*A010*

*79 Guilford Street, WC1N 1DF*

*Listed Building Consent and Non-Material Amendment Application for Roof Structure and Layout and Front and Rear Wall Structural Works.*

This statement sets out proposed non-material amendments to the approved Planning and Listed Building Consent at 79 Guilford Street. These applications were granted in July 2020 (ref: 2019/2546/P and 2019/3006/L respectively).

### 3.0 Elbow Ties

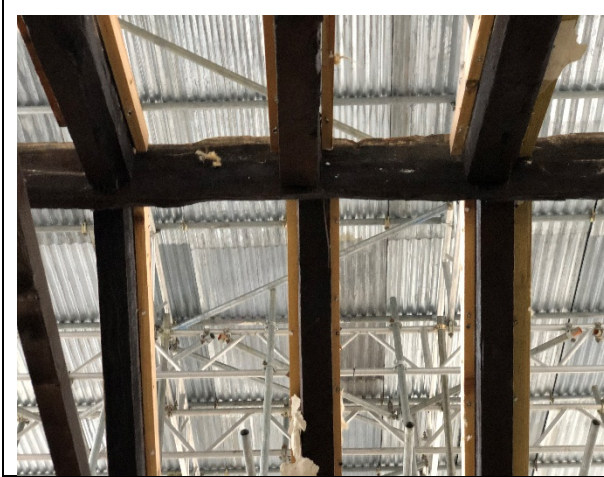
Due to the severity of the cracking between the front/rear walls and the party walls, there was a need to tie them together as soon as possible to prevent further movement. As the scaffold was not installed to the front or rear, a normal Cintec anchor tying detail could not be achieved safely. Therefore concrete 'elbows' were installed as set out in the structural engineer's statement appended.

To protect the curved plaster to the staircase, it was suggested that the elbows were not installed to the rear left hand party wall at ground – second floor (with No. 78 Guilford Street) and a Cintec anchor detail will be used once the rear scaffold is constructed. These could also not be installed at ground floor to the left-hand side party wall at the front, next to the front door. A Cintec anchor detail will be used here also.

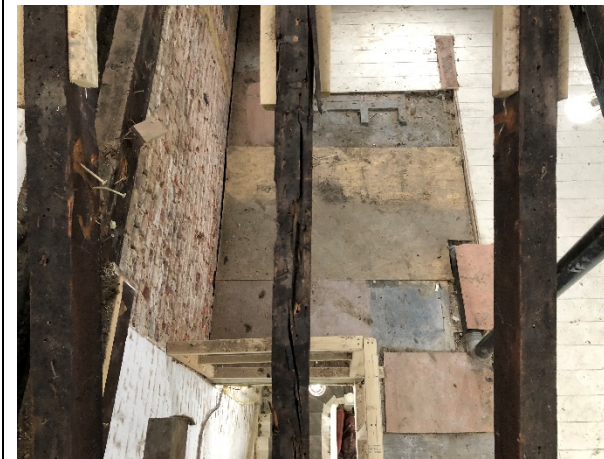
Ridge beam as viewed from below. Note: beam is very thin and has decayed from the top.

View across roof. Note condition of ridge beam and evidence of previous unsuccessful strengthening measures.

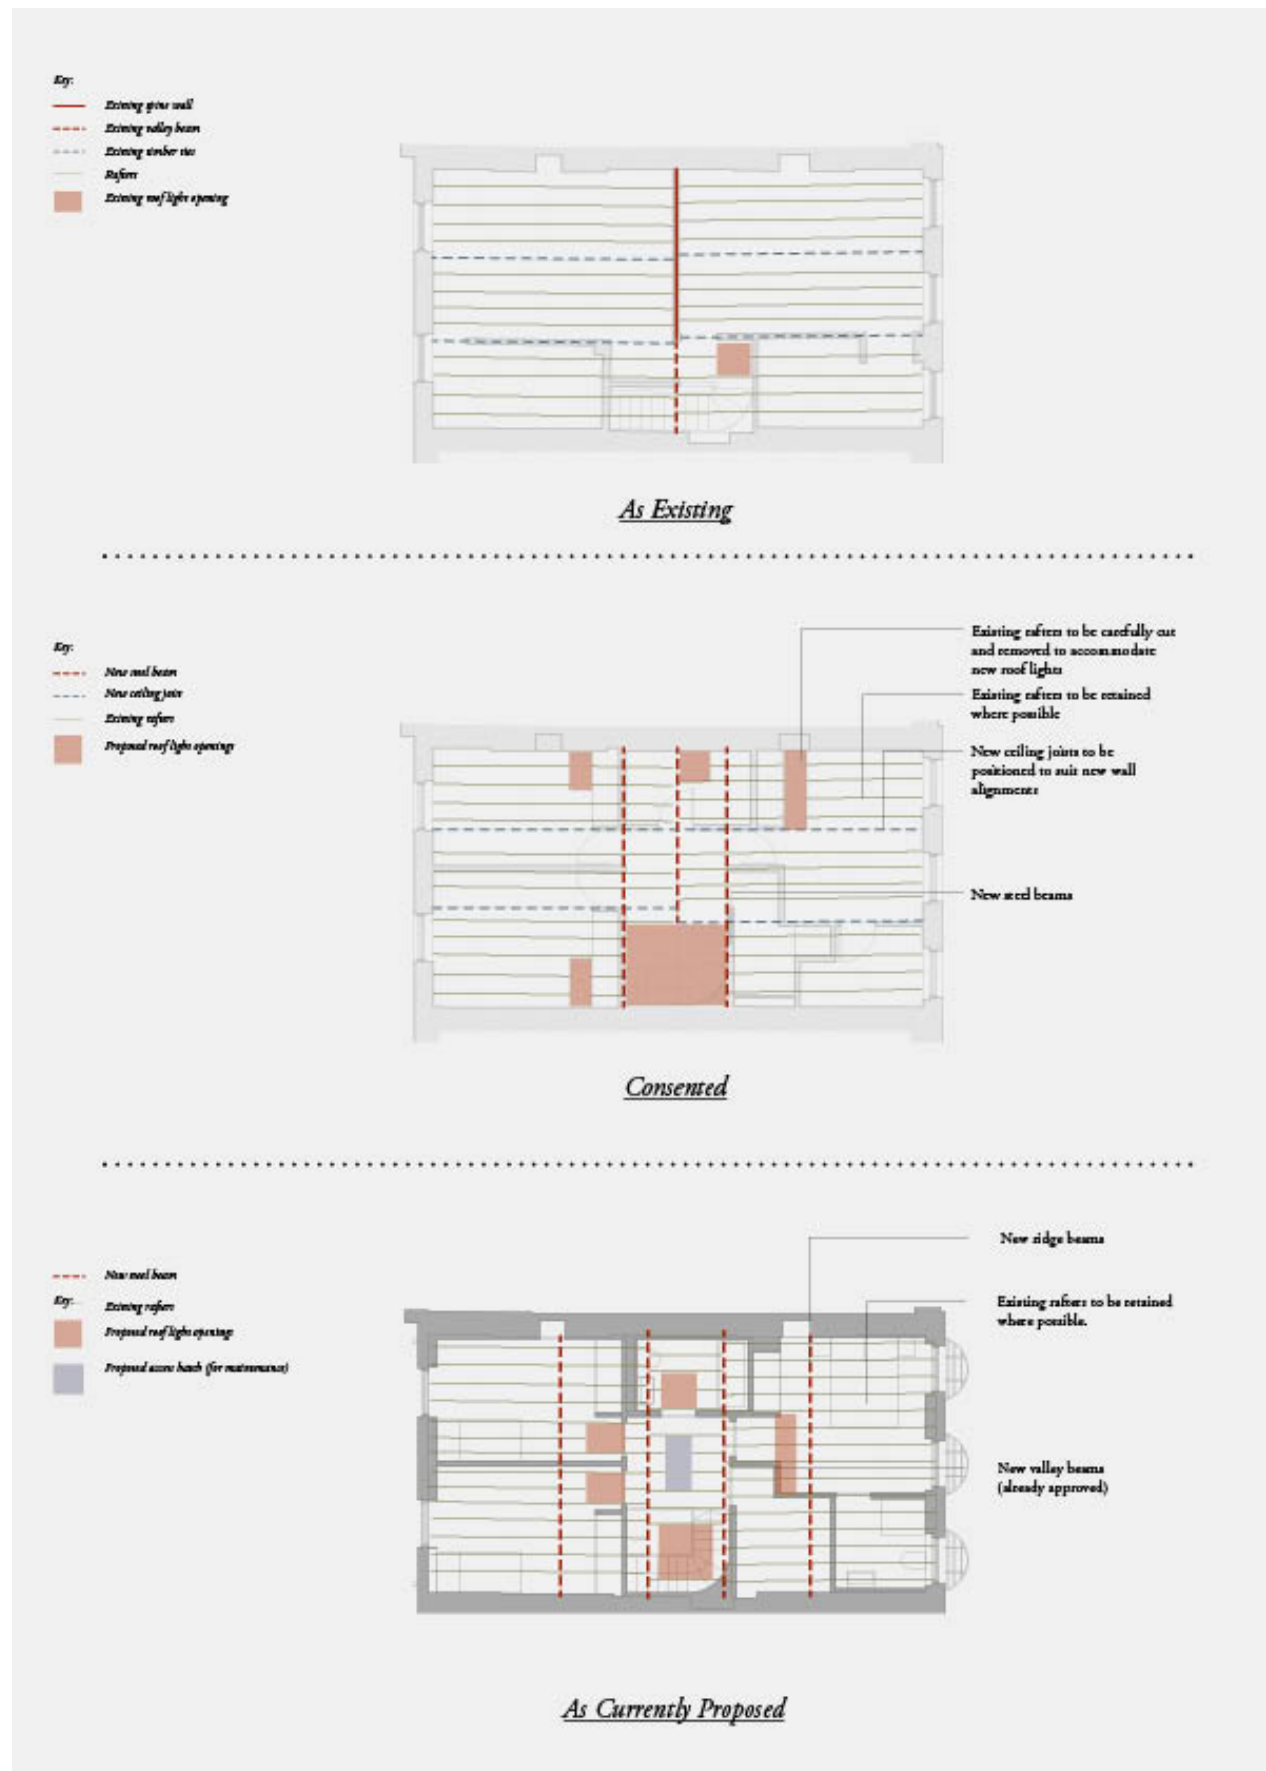
View of rafter with severe cracking.

Example of timbers that have been cut into shorter lengths and then fixed back together.

View of ridge beam viewed from roof level.
